PROPOSED WAREHOUSE

PROPOSED LOT 505 on SP316171 301 Coastlink Court, Stapylton

LANDSCAPE PLANS APPROVED

Application No.: OPW/2025/1127

Drawing No: L-PRI- CP00
Rev. No: 3

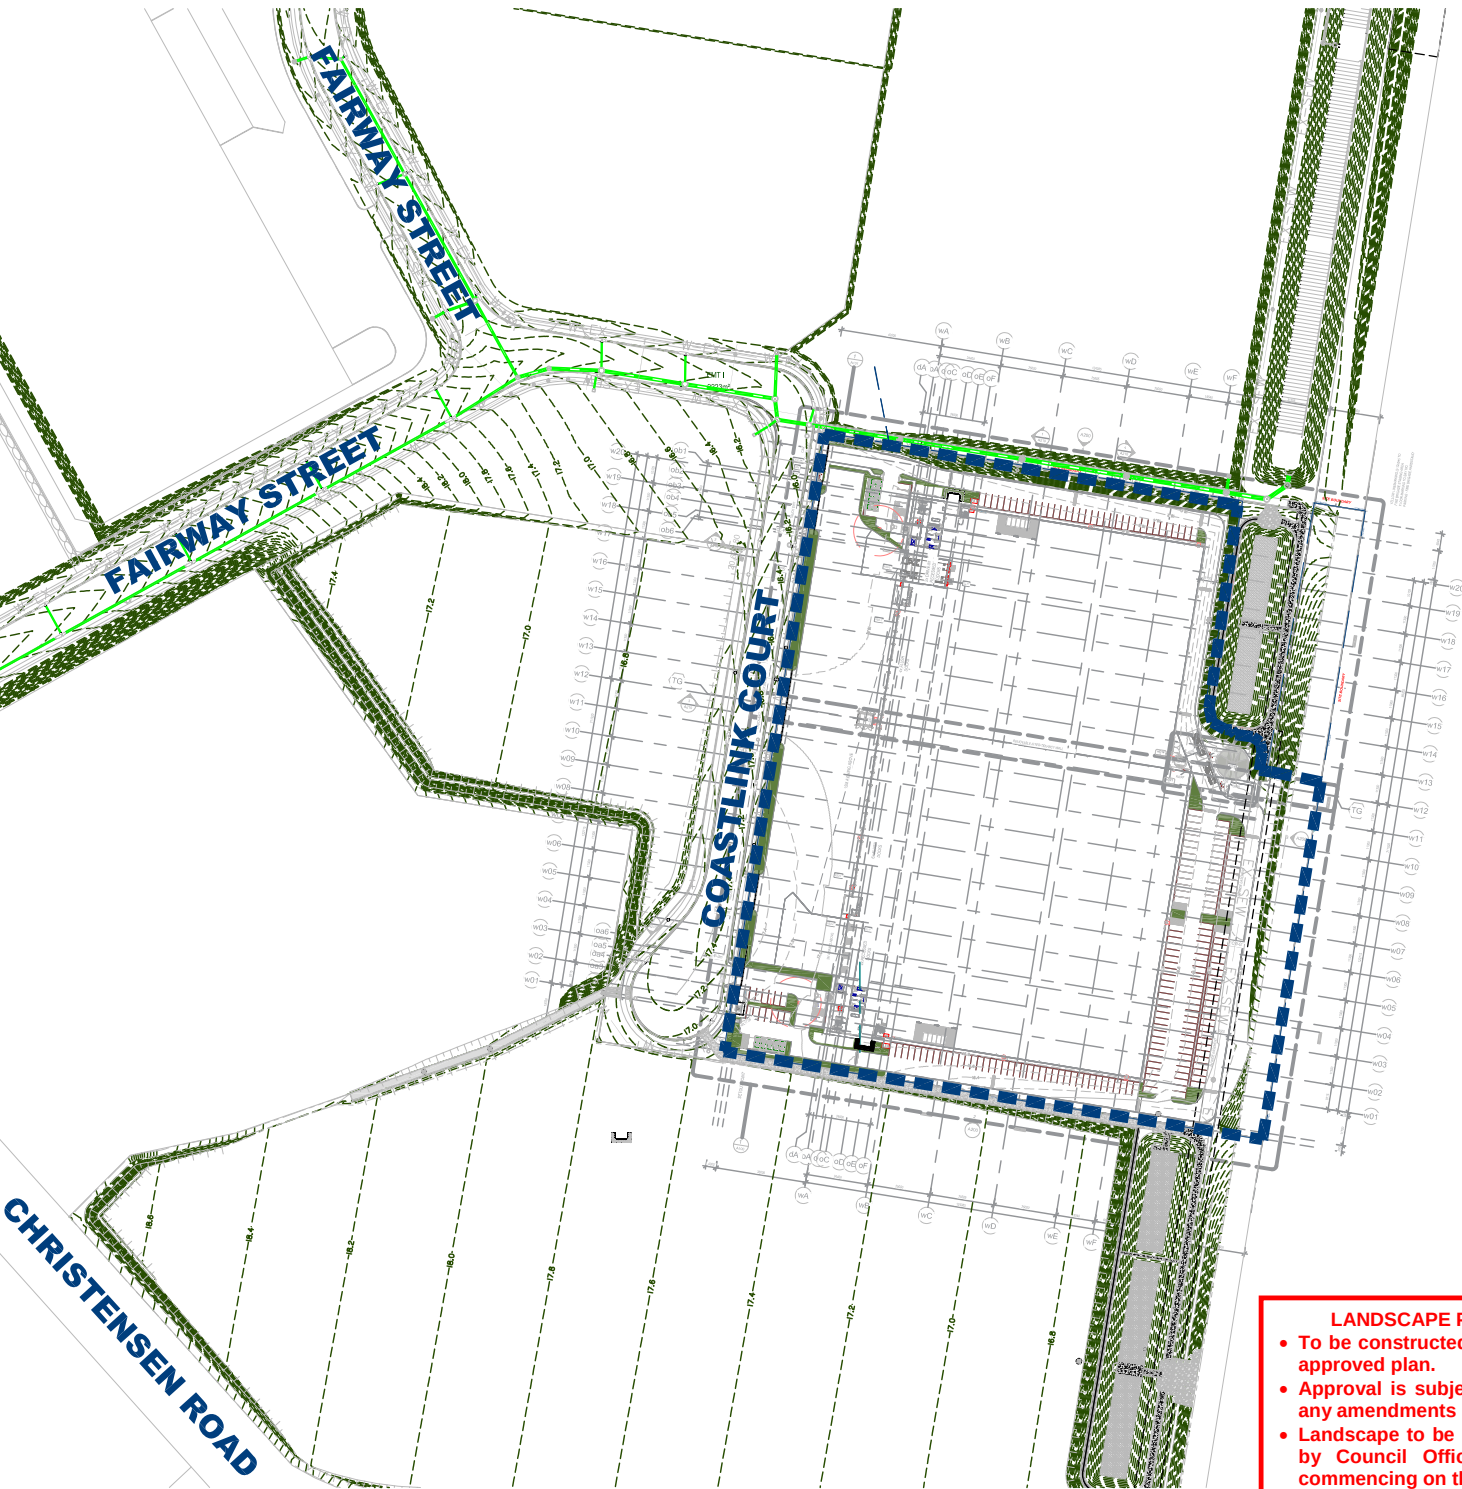
LANDSCAPE ASSESSMENT NOTES:

- All under sized or poor quality stock will be required to be replaced prior to inspection approval.
- Existing Street trees to be retained and protected. Damaged street trees are to be replaced with the same species at the same size. Replacement street trees must be staked, mulched and edged as per City of Gold Coast Street Tree Planting - Setout Guidelines.

- Street trees to be, staked, mulched and edged as per City of Gold Coast Street Tree Planting - Setout Guidelines. Must be setback a minimum 3m from the proposed driveway and 1m setback from the nominal kerb line.

- All road reserve turf must be repaired or replaced if damaged.
- All trees must be staked, edged and mulched.
- Ensure all nominated existing planting to be retained and protected are not damaged. Plants damaged in construction must be replaced with the same species at the same size.

- Ensure all proposed trees within the private lot are setback 3m minimum from the proposed roof line or building foundations. Only small trees are permitted within the 2-3 metre setback from proposed roof line or building foundations, but a root barrier must be used.

- All planting to be within an edged and mulched garden bed complying with the City Plan Policy - Landscape Work.
- All nursery bamboo stakes and plastic/rubber ties must be removed from planted tree specimens before final inspection.

Plant quantities will need to be updated. Refer mark ups on landscape plans for revised plant quantities.

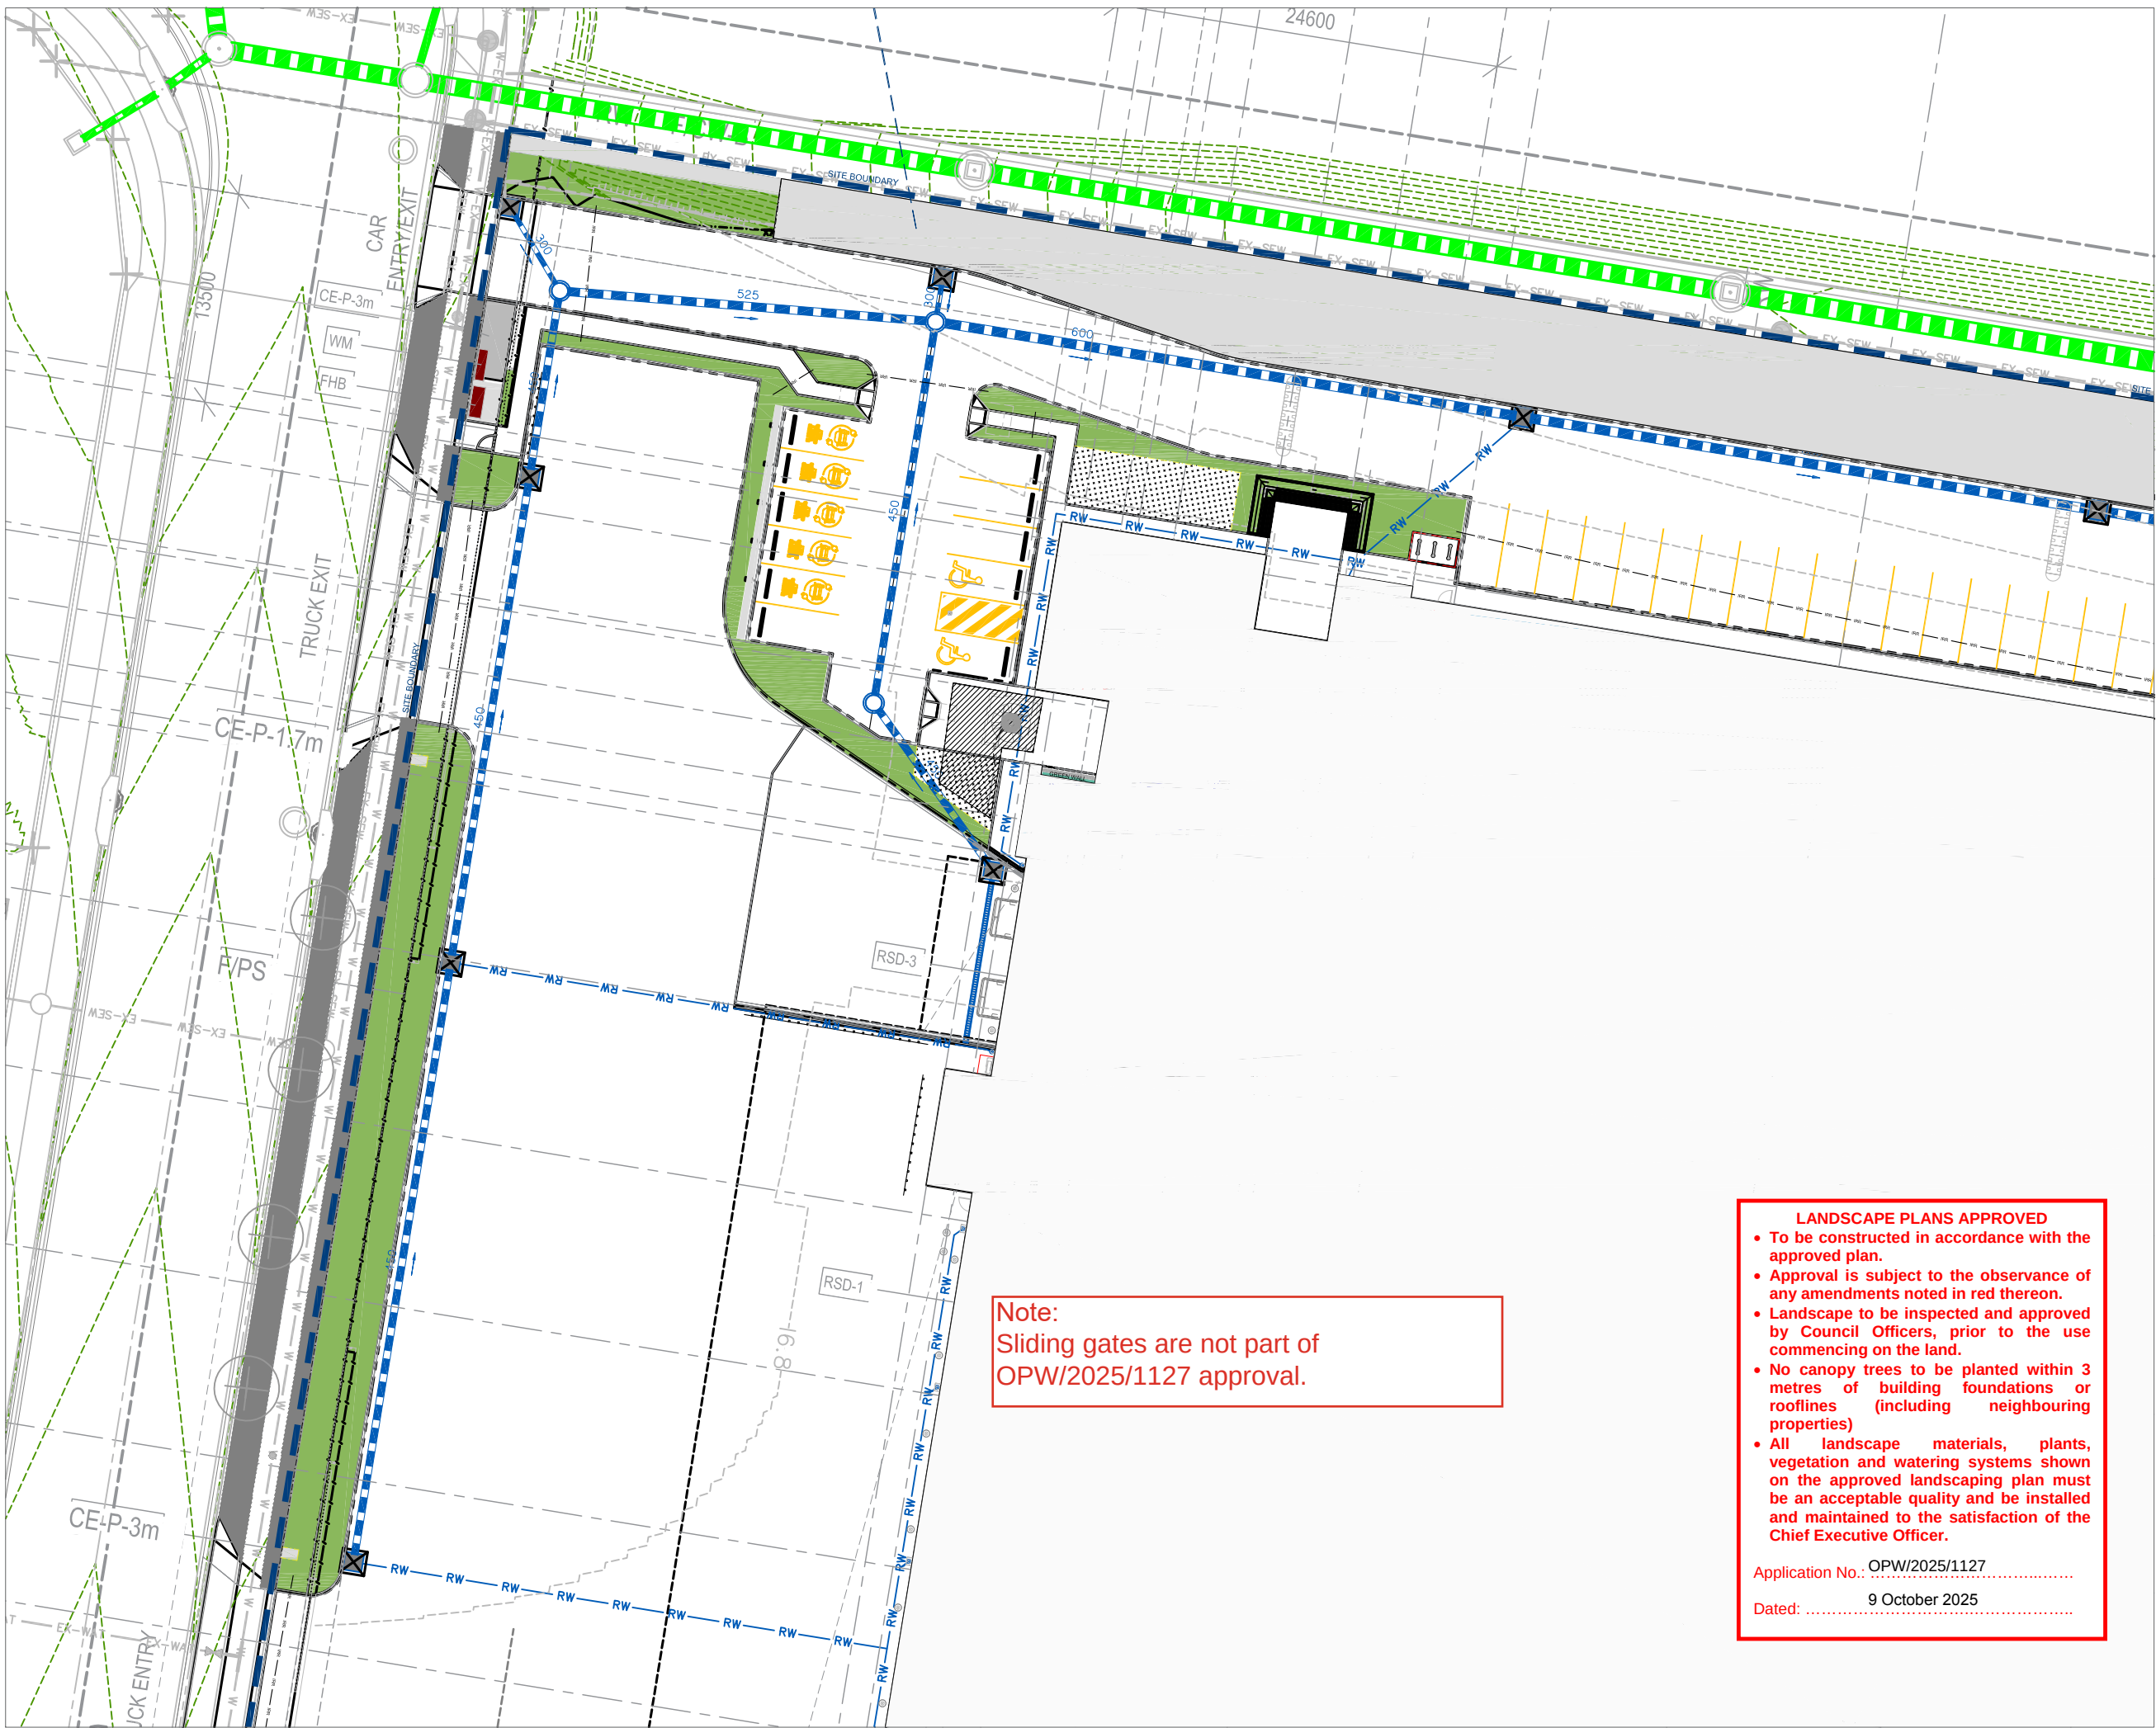
Note:
Sliding gates are not part of
OPW/2025/1127 approval.

Drawing No:	Rev. No:
L-PRI-ST02	3

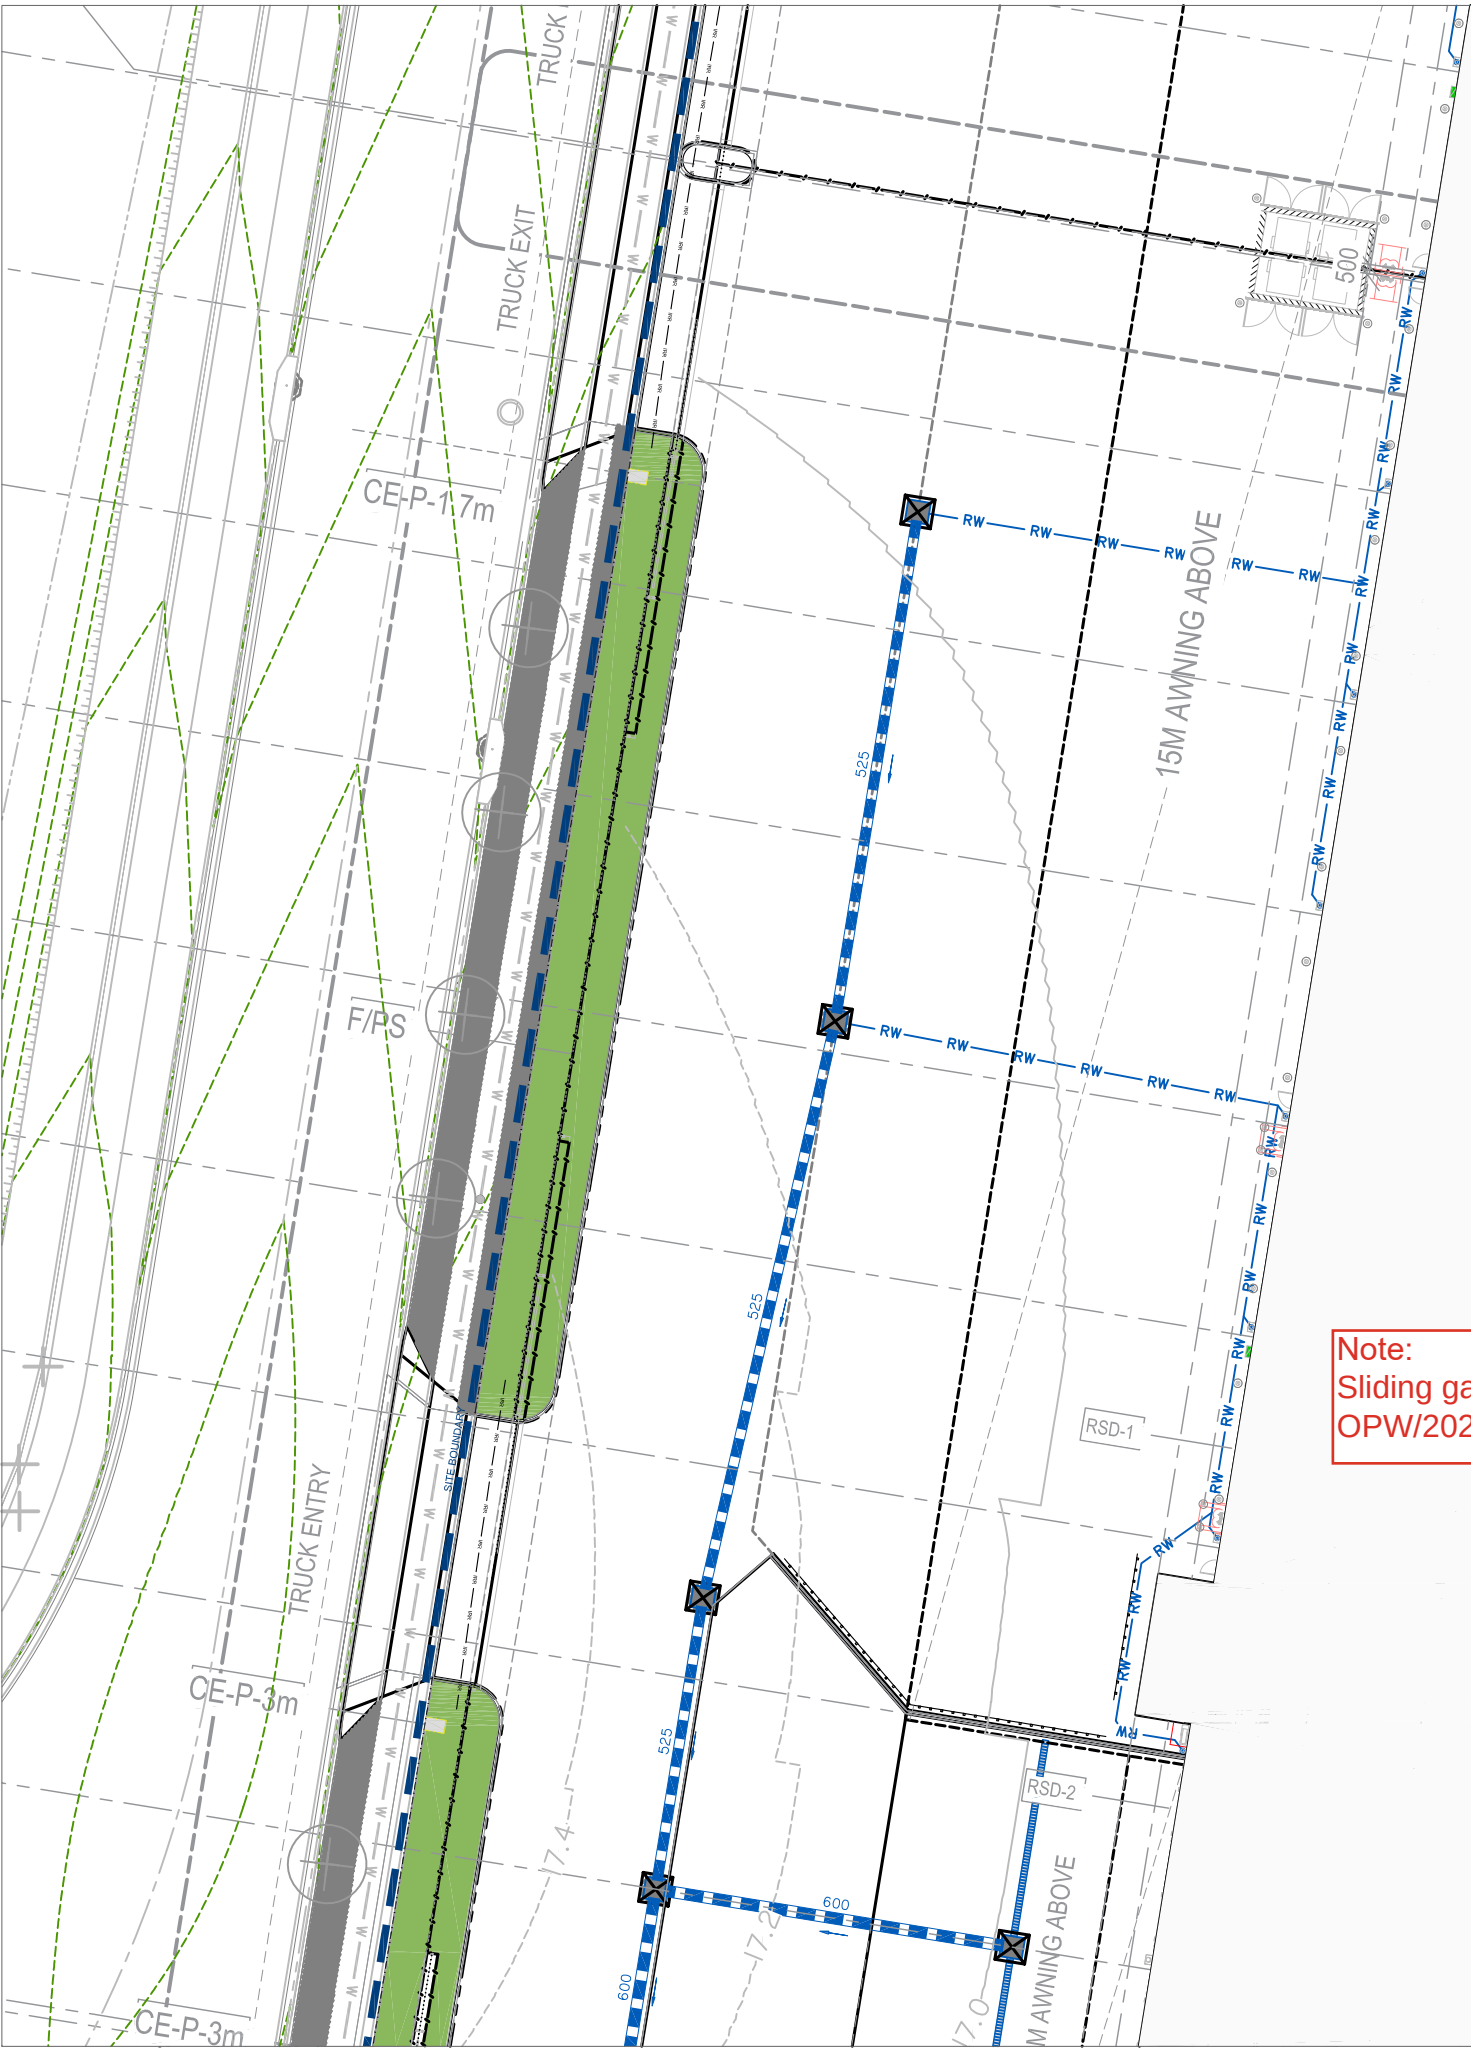
Note:
Sliding gates are not part of
OPW/2025/1127 approval.
